Serial No:10/688053
Docket No: Rennich-001

AMENDMENT IN THE DRAWINGS

FIG. 5

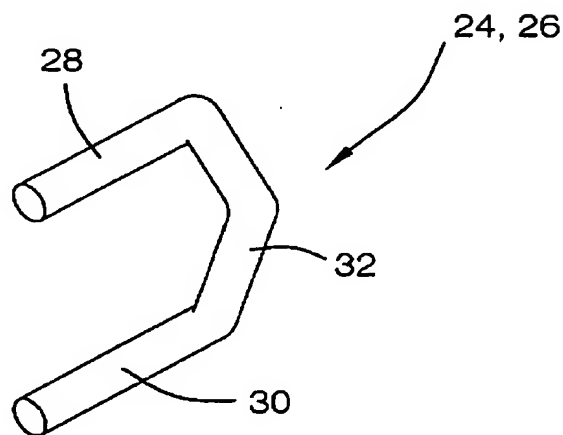
Examiner, on examiner's action page 2, has requested the addition of a perspective view of the alternate embodiment of pins 24 and 26 as illustrated in Figure 4. A replacement sheet of drawings including an additional Figure 5 is being submitted herewith in accordance with 37 CFR 1.121(d). Figure 5, is a perspective view of the alternate embodiment of pins 24 and 26 illustrating the bridge portion 32 bent at a mid point.
